City of Alexandria, Virginia

MEMORANDUM

SUBJECT: UPDATE ON PERMIT TO DEMOLISH, ADDITION AND ALTERATIONS
AT 207 PRINCE STREET, BAR CASE #2013-0066 & 0067

Physical Investigation and Documentation of the Fairfax–Moore–Montague House Kitchen

Figure 11: First floor alternate design presented by BAR Staff that preserves the historic masonry walls in what is, perhaps, the oldest part of the house

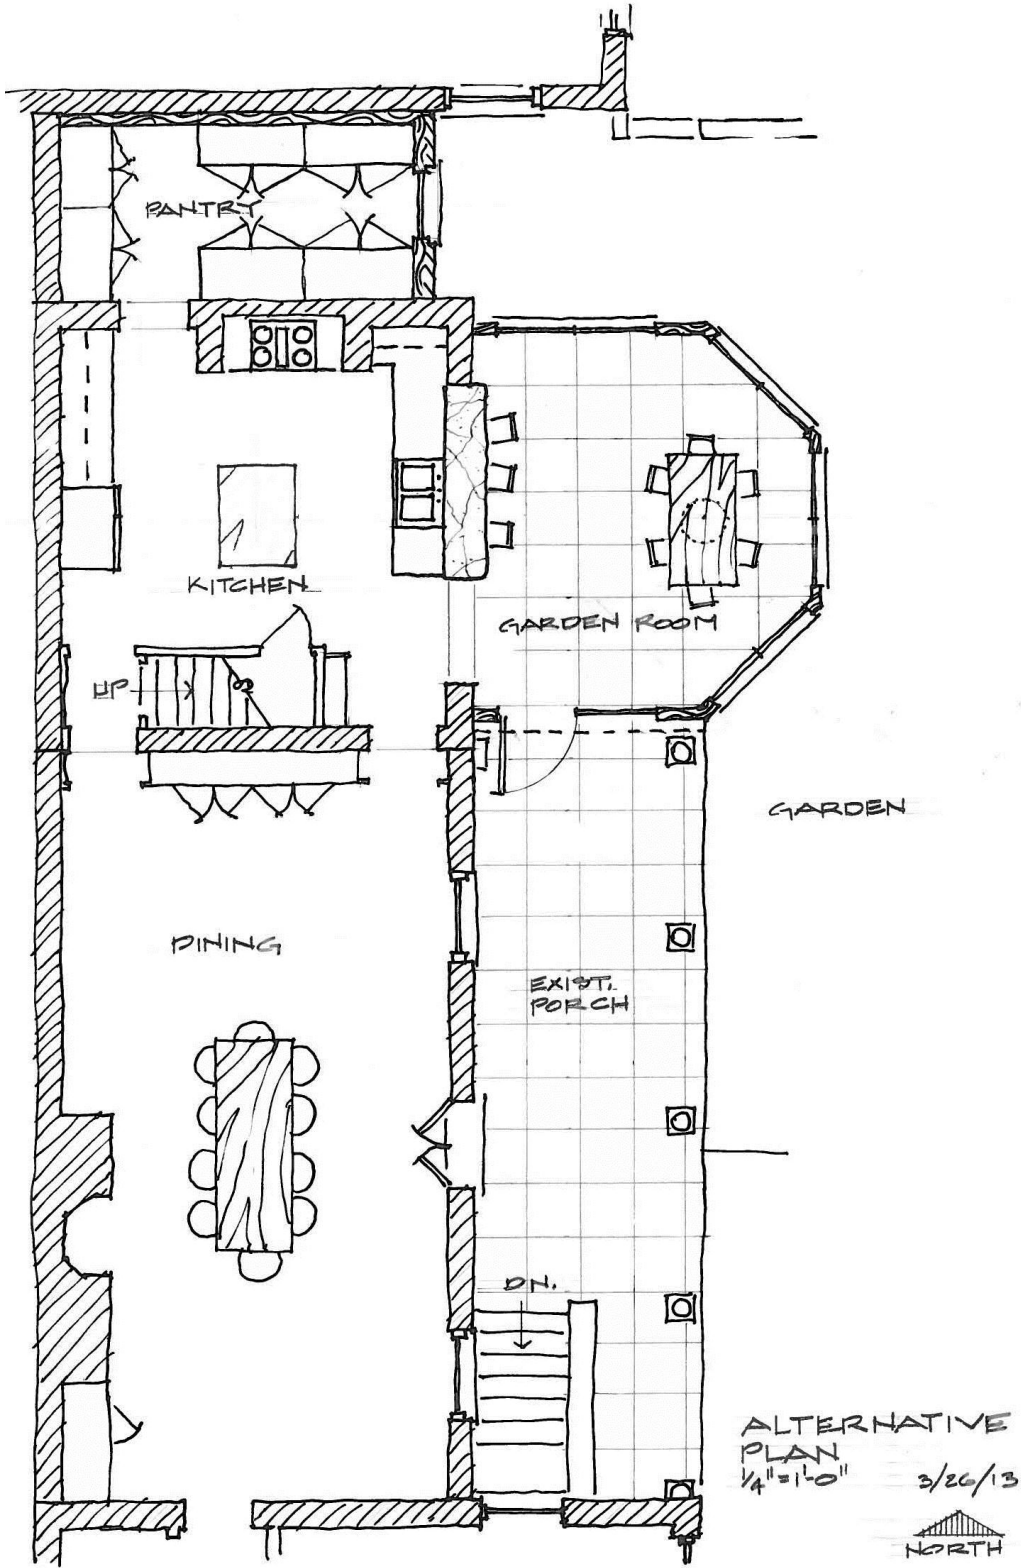
Therefore, Staff recommended to the applicant an addition much smaller in height and floor area that does not try to match the original building or the 1930's Colonial Revival alterations, but stands on its own. A delicate single story kitchen projecting slightly beyond the existing porch, much like a Colonial Revival conservatory, would read as a garden feature rather than part of the house and take up very little useable open space in the garden. Like the plan submitted by the applicant, a one-story addition would still provide generous kitchen work space, substantial pantry storage and circulation for entertaining and daily use by the family. The masonry opening to the garden room could be a large segmental masonry arch with a wood vaulted ceiling in the garden room/breakfast area to allow light back into the kitchen. A similar design was recently approved by the BAR at 504 Prince Street. The alternative designs suggested by Staff are illustrated in *figure 10* and *figure 11*.

Although Staff would prefer that a greater portion of the north and east masonry walls at the first floor be preserved and incorporated into the new plan, Staff acknowledges that these masonry walls have been altered many times in the past and has no objection to the exterior design of the proposed kitchen addition. As historic maps and photographs show, there have been several alterations to the east elevation over the years. The visual mass of the proposed addition has been significantly scaled back since the initial application and its impact on the existing east elevation minimized by the elimination of the second story covered porch.

Figure 13: Revised proposal by applicant and current application submission

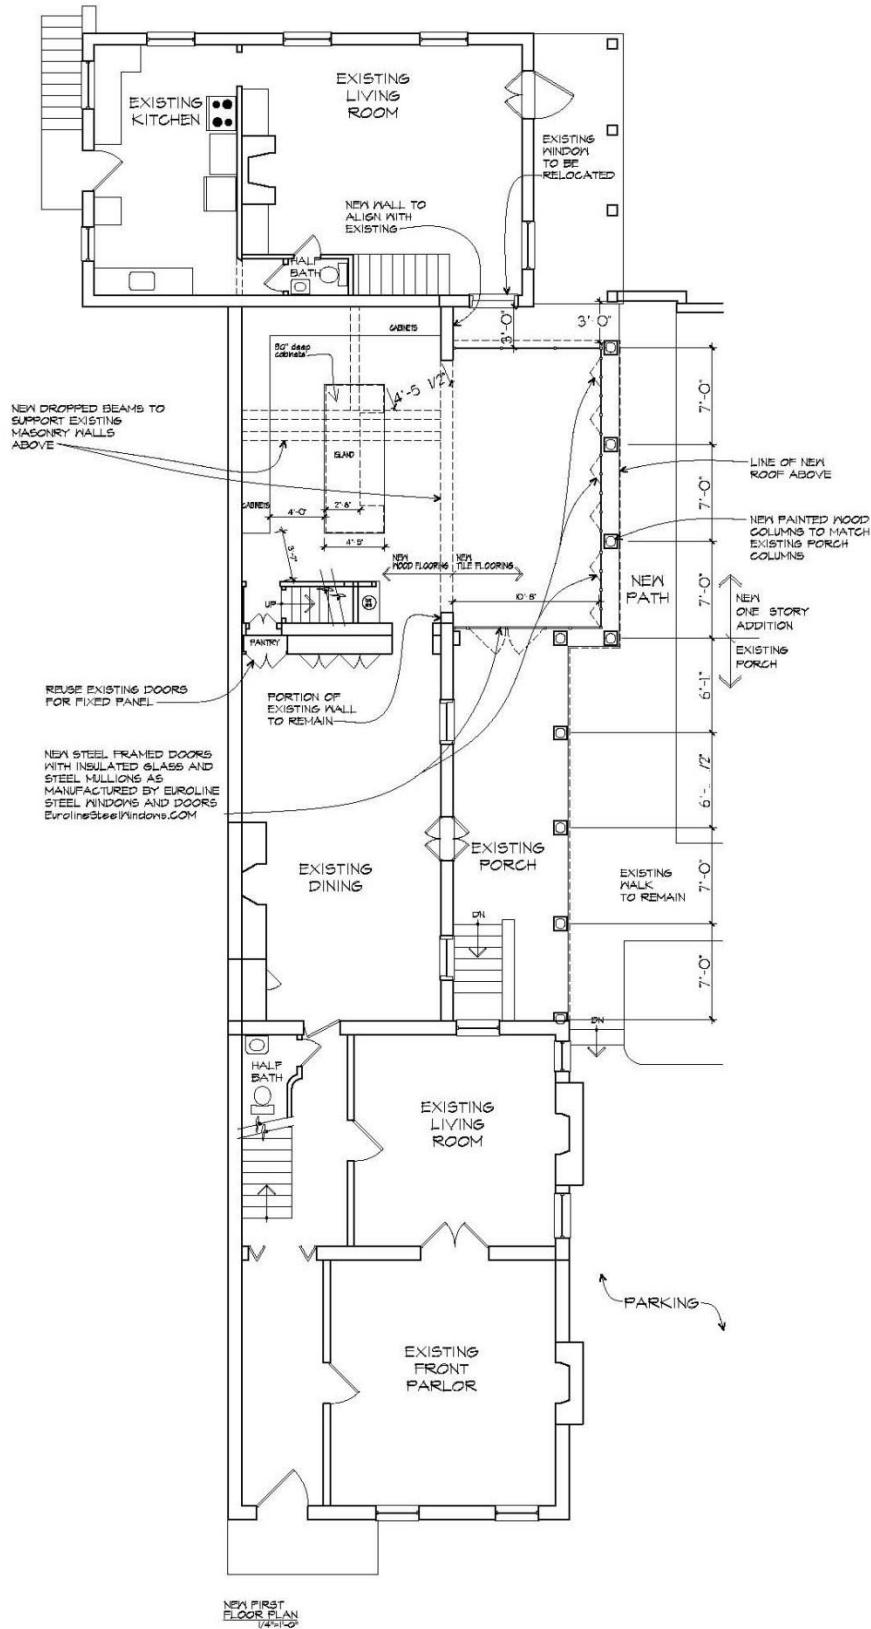
The proposed enclosed porch design parti is often used on historic buildings to avoid competing with the primary building mass. The size and spacing of the new columns recall the existing porch without replicating the segmental arch detail of that Colonial Revival era design. The modern steel and glass doors on the proposed addition float behind the columns and clearly distinguish this infill as a modern addition. The applicant has alluded to floor material changes and ceiling design that will visually interpret the location of the original masonry walls and it is Staff's recommendation that this be made a condition of the Certificate of Appropriateness. Furthermore, Staff recommends that an approval for a Permit to Demolish include the condition that the historic floor joists of the first and second story remain in place. These alterations, if approved, will preserve the historic integrity and understanding of the evolution of this important house while allowing its inhabitants a contemporary kitchen and living space.
